Date: 19-12-2012

LP8 – an upgrade makes a lifting capacity of 350 kg possible

New model with inside cables

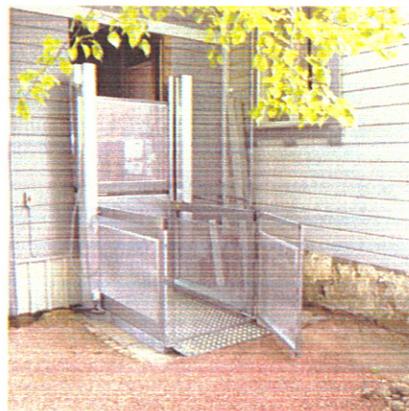
Inside wiring – leads to a much nicer appearance

The small cable box on top of the left post has been removed and the loose cable on the left side has been concealed. Now the cable is inside the post – hidden so it does not disturb the appearance of the lifting platform.
